**Referral 44: VCAT Call-in P1537/2023  
155 Johnston Street, Fitzroy**

**Priority Projects Standing Advisory Committee Report**

**24 January 2025**

**Figure 8** Scale of surrounding development

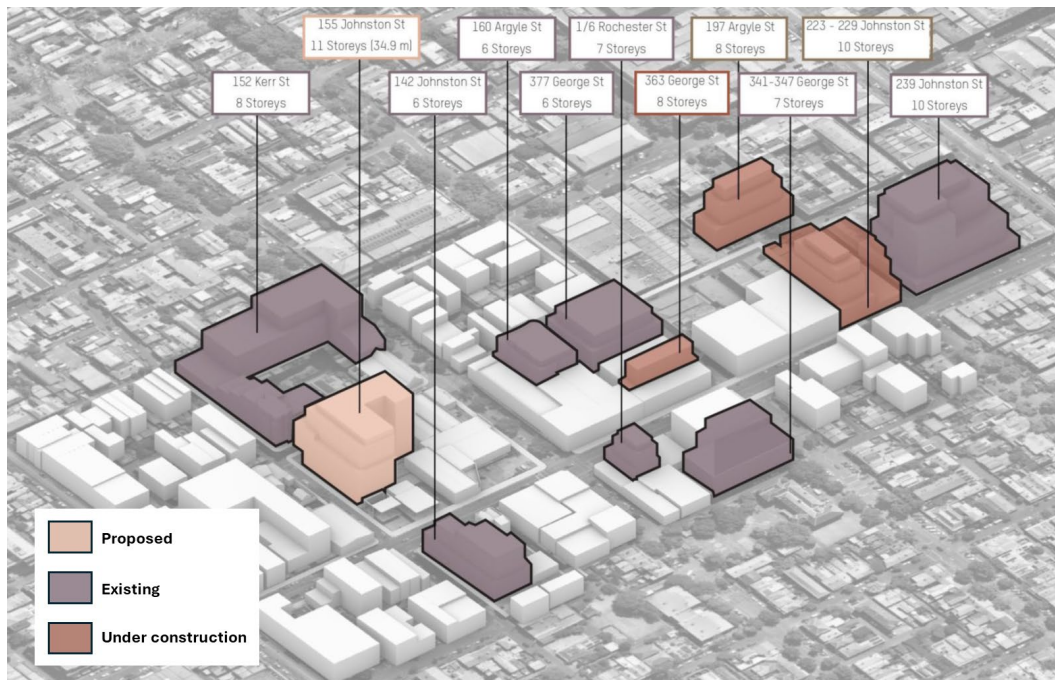
Mr O'Dwyer stated the proposal was an appropriate response to the neighbourhood character, built form, height, and scale of the context (Figure 8).

**Figure 9** Profile of development with land to the north

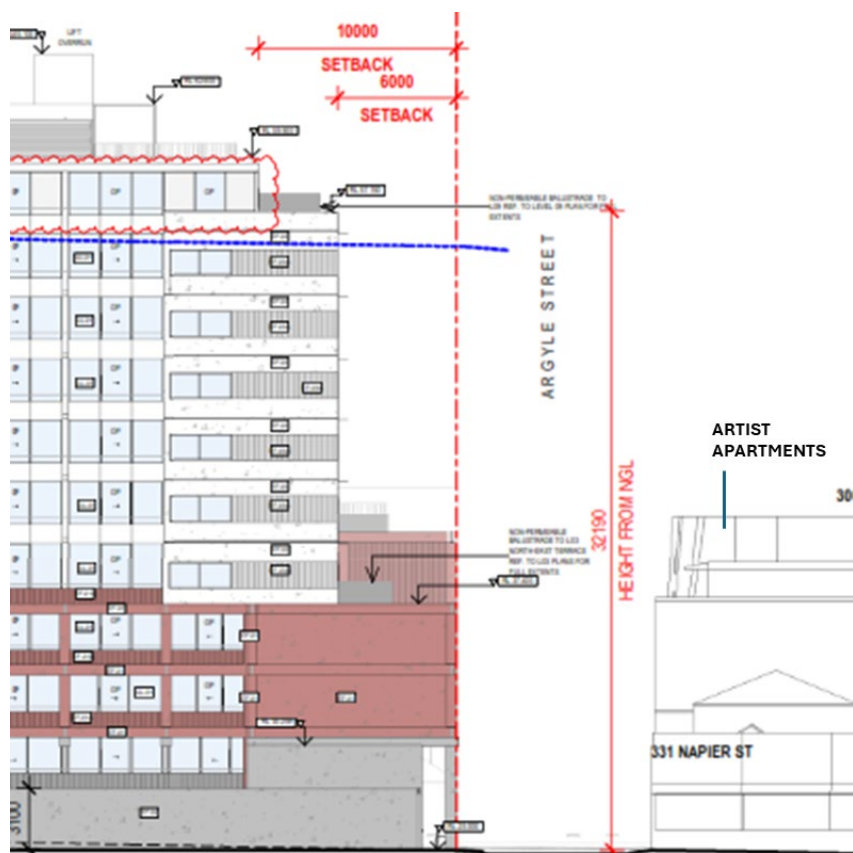
- offers a satisfactory transition to the specific residential conditions to the north of Argyle Street in the context of the building height requirements
- has no adverse consequences on the amenity of the public realm or neighbouring properties that would require further transition measures
- the stepped profile responds positively to the scale and robust nature of Argyle Street, including the Artist Apartments and double storey terrace houses to the north (Figure 9).
